Contract #: 04-0120F4Cty: SF/ALA Rte: 80 PM: 13.2/13.9File #: 69.25B**QUALITY ASSURANCE -- NON-CONFORMANCE REPORT****Location:** Changxing Island, Shanghai, PRC**Report No:** NCR-000359**Prime Contractor:** American Bridge/Fluor Enterprises, a JV**Date:** 11-Jul-2009**Submitting Contractor:** Zhenhua Port Machinery Company, Ltd (ZPMC), Changxing Island**NCR #:** ZPMC-0333**Type of problem:**

Reference Description: CWR Not Followed During Repair**Description of Non-Conformance:**

Job Name: SAS Superstructure

Subject: NCR No. ZPMC-0333

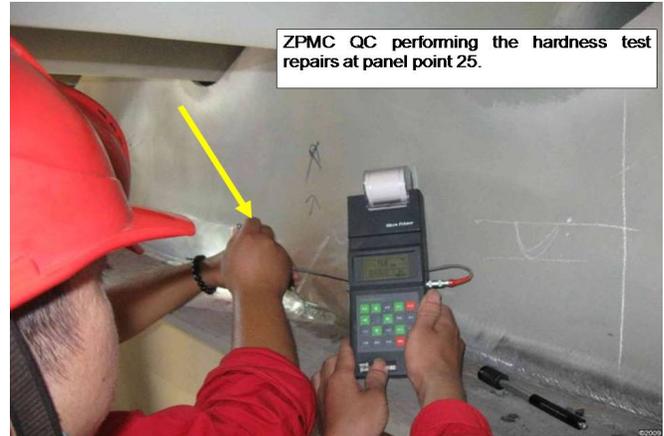
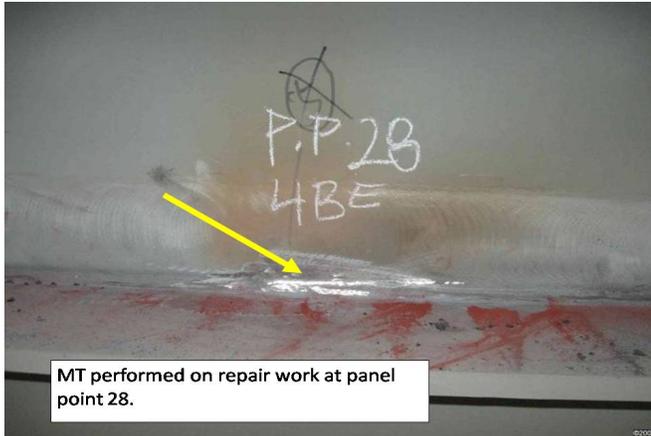
Caltrans Quality Assurance (QA) Inspector observed Critical Welding Repair (CWR) work was performed on Floor Beam to Diaphragm welds (SSD19-PP024-004/005, SSD20-PP025-004/005, SSD16A-PP026-003/004, SSD17A-PP027-003/004, SSD18A-PP028-004/005) located at Panel Points 24~28 of Segment 4AE and 4BE. The CWR is associated with the removal of transverse cracks observed by Magnetic Particle Testing (MT) performed by ZPMC. The below listed observations do not comply with the approved Critical Weld Repair procedure (B-CWR-595 R1).

1. ZPMC did not provide a written or verbal notification to the Engineer prior to performing Hardness Testing and facilitate the Engineer to witness the testing. Hardness Testing was only performed after the repair work was complete with no prior Engineer Notification provided by ZPMC.
2. The results of the Hardness Testing were not provided to the Engineer for review prior to repair.
3. A separate CWR is needed if cracks are found in the base metal HAZ.
4. If excessive root gap (5mm or more) is found during grinding of the repair area. The contractor shall seek Engineers approval.
5. Gouging shall not be used for this repair.

The proposed resolution is acceptable. The hardness testing results mentioned in the attached documents have been received in China. Also, the welds in question have been accepted by MT and UT as shown in the attached documents. The Department concurs that Non-Conformance ZPMC-0333 is closed.

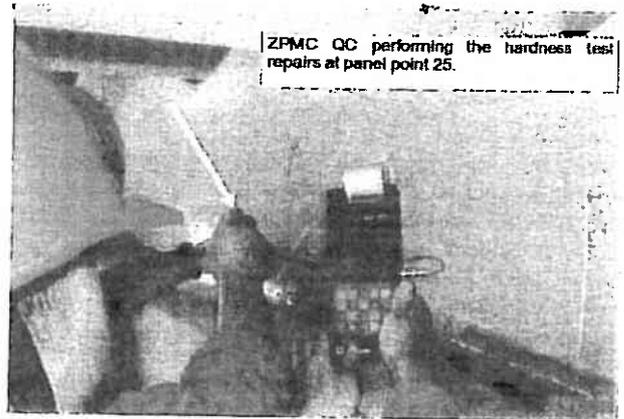
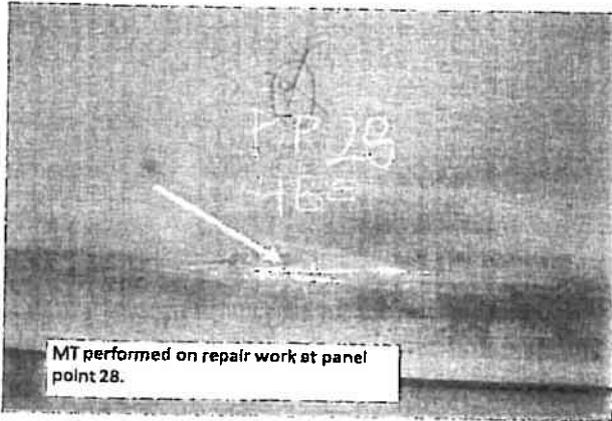
Caltrans Quality Assurance (QA) Inspector observed Critical Welding Repair (CWR) work was performed on Floor Beam to Diaphragm welds (SSD19-PP024-004/005, SSD20-PP025-004/005, SSD16A-PP026-003/004, SSD17A-PP027-003/004, SSD18A-PP028-004/005) located at Panel Points 24~28 of Segment 4AE and 4BE. The CWR is associated with the removal of transverse cracks observed by Magnetic Particle Testing (MT) performed by ZPMC. The below listed observations do not comply with the approved Critical Weld Repair procedure (B-CWR-595 R1).

1. ZPMC did not provide a written or verbal notification to the Engineer prior to performing Hardness Testing and facilitate the Engineer to witness the testing. Hardness Testing was only performed after the repair work was complete with no prior Engineer Notification provided by ZPMC.
2. The results of the Hardness Testing were not provided to the Engineer for review prior to repair.
3. A separate CWR is needed if cracks are found in the base metal HAZ.
4. If excessive root gap (5mm or more) is found during grinding of the repair area. The contractor shall seek Engineers approval.
5. Gouging shall not be used for this repair.

Critical Welding Repair Report (CWR)

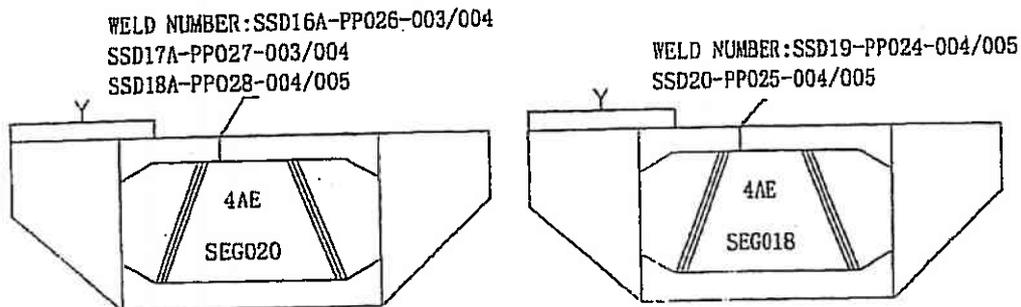
Eighteen cracks were found by use of MT on weld SSD19-PP024-004 Welder ID No.058551 Position:2F Y1=40;Y2=3175;Y3=7100;Y4=10950;Y5=12280;Y6=14920;Y7=15900;Y8=15970;Y9=16080;Y10=16150;Y11=16520;Y12=17450;Y13=17660;Y14=18400;Y15=18680;Y16=18750;Y17=18800;Y18=19000;

- Hardness testing is req'd at every location where the trans. cracks found
- The readings of the test shall be done along the weld and adj. base metal
(Ref: TC-20)
车间负责人 (Foreman): Li Zhigang 日期 (Date): 09.07.03 for further remarks

- Provide written & verbal notification to the engr. prior to the hardness testing for engr. to witness the testing.

1. The Engineer shall be notified and present during this repair. Indicate repair procedure, if illet weld; gouging shall not be used for this repair
2. QC and a Lead CWI shall be present and direct all gouging, grinding and welding operations during this repair.

3. QC and a Lead CWI shall have an approved copy of the CWR in hand prior to the repair.
4. QC and a Lead CWI shall direct the repair to ensure the repair is per the disposition requirements.

5. Paint shall be removed in the area requiring MT; - ET
6. Remove the crack by means of grinding. 2009. 7. 4.
7. Prepare excavation according to the approved repair WPS.

8. Before this repair, Verify with VT and MT repair areas are crack free, and also MT shall be perform on the base metal nearby transverse cracks to ensure that no cracks we re propagated in to the base metal;

9. Preheat and weld according to the approved repair WPS.
10. Grind the repaired area flush with base metal or the adjacent weld.
11. Perform VT after repair and additional% NDT requirement stated in special provisi on 10-1.59 "inspection testing" note 3;

12. 100%MT all these welds after the weld repair, including the opposite side of the r epaired weld that didn't require repair previously.

关键焊缝返修报告
Critical Welding Repair Report (CWR)

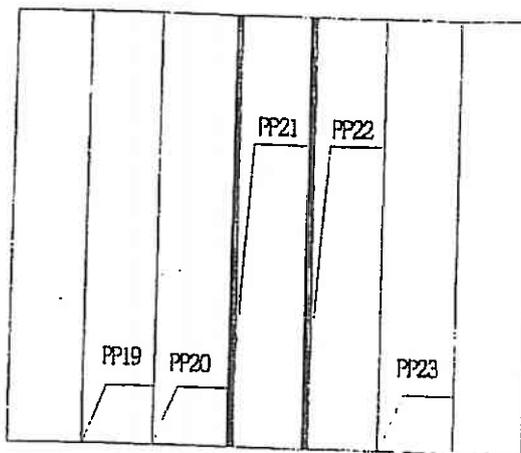
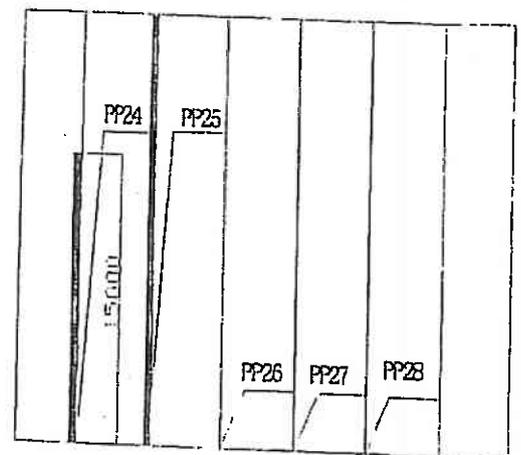
According to the ABF requirement that PP21/PP22 of 3E and PP25 of 4E, PP24 from first Y point of CWR595R1 to 15000 mm ,gouging welds both sides and change the weld joints to CJP.

9. 同返修程序5;
10. 进行VT和MT检测。
1. Remove weld by gouging entire length. For Segment 4E panel point 24, the transition from CJP to Fillet shall be a 2-1/2 to 1 taper.

2. Grind weld prep to bright metal.
3. MT weld preparations to verify cracks are completely removed and do not exist in the Base Metal.
4. Pre-heat base metal to 65-100°C;

5. Progressive welding, each weld pass is about 600mm, and each pass end should be covered with the next pass initial 50mm. after welding total first weld pass, use progressive weld to finish second weld pass to finish single side weld;

6. Backgouging second side welds as required by grinding or gouging.
7. MT backgouge.
8. Pre-heat weld to 65-100°C;
9. Progressive welding, each weld pass is about 600mm, and each pass end should be covered with the next pass initial 50mm. after welding total first weld pass, use progressive weld to finish second weld pass to finish welding of second side.

10. Perform VT and MT weld after cooling to ambient temperature.
- PERFORM UT ON ALL CJP REPAIRS.*
- MT FILLET WELD ON BOTTOM SIDE OF FLANGE.*
- IF ENTIRE WELD IS REMOVED BY GOUGING, REMOVE CRACKS BY GRINDING PRIOR TO PERFORMING GOUGING.*

WELD NUMBER: SSD20-PP025-004/005

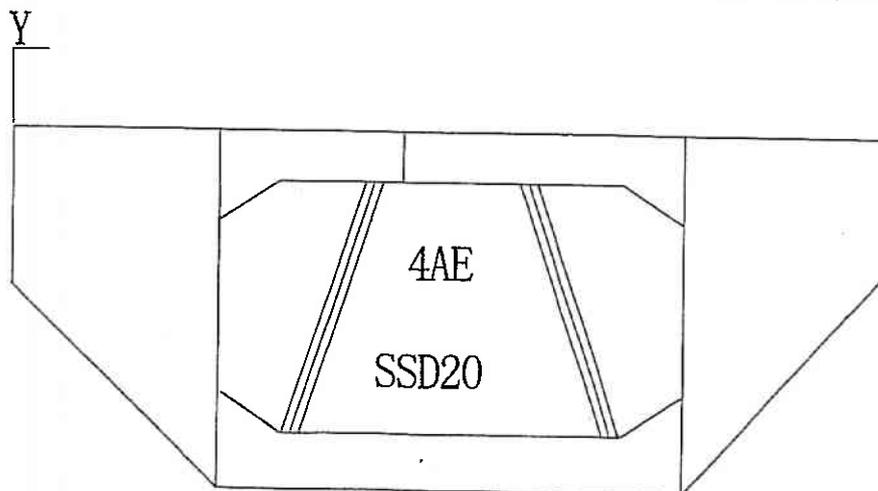
Two longitudinal cracks and Six transverse cracks were found by use of MT on SSD20-PP025-004

Six longitudinal cracks and eight transverse cracks were found by use of MT on SSD20-PP025-005

1. QC and a Lead CWI shall be present, direct and supervise all grinding and welding operations during this repair to ensure the repair is per the disposition requirements

2. QC and a Lead CWI shall have an approved copy of the CWR in hand prior to the repair.
3. Remove paint ≥ 25 mm in all direction of HAZ prior to MT.
4. Remove cracks by grinding, repair area shall extend a minimum of 50mm beyond each end of single crack repairs, and 50mm beyond the outermost cracks for multiple crack repairs.

5. If base metal is damaged by grinding, the damaged area shall be ground clean prior to performing weld repair. If gap > 5 mm is found during or after grinding, a CJP weld is required in that location, and perform MT after performing grinding the defects away.

6. Prepare excavation in accordance with an approved repair WPS prior to welding.
7. Before this repair, Verify with VT and MT repair areas are defects free, and also MT shall be performed on the base metal laying abroad cracks to ensure that no cracks were propagated to the base metal. Separate CWR approval is needed if cracks are found in the base metal.

8. Preheat and weld according to the approved repair WPS.
9. Grind the repaired area flush with base metal or the adjacent weld.
10. Perform MT inspection to all repaired welds (along with an additional 50mm at each end of the weld repair) which include the near side and far side on the upper and bottom side of flange in the same area where the repair was performed according to additional NDT requirement stated in special provision 10-1.59 "inspection testing" note 3. Perform UT and MT inspection to CJP weld.
